NO: HIFI2-00-001

SUBJECT: REPLACEMENT OVERWRITE HEAD

MDS-302

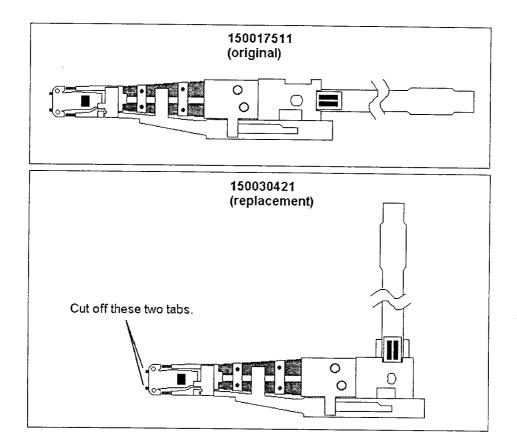
SYMPTOM: The replacement overwrite head contacts the mechanism frame.

SOLUTION: Remove the two protruding tips of the overwrite head P/N 150030421 before it is installed

(see diagram).
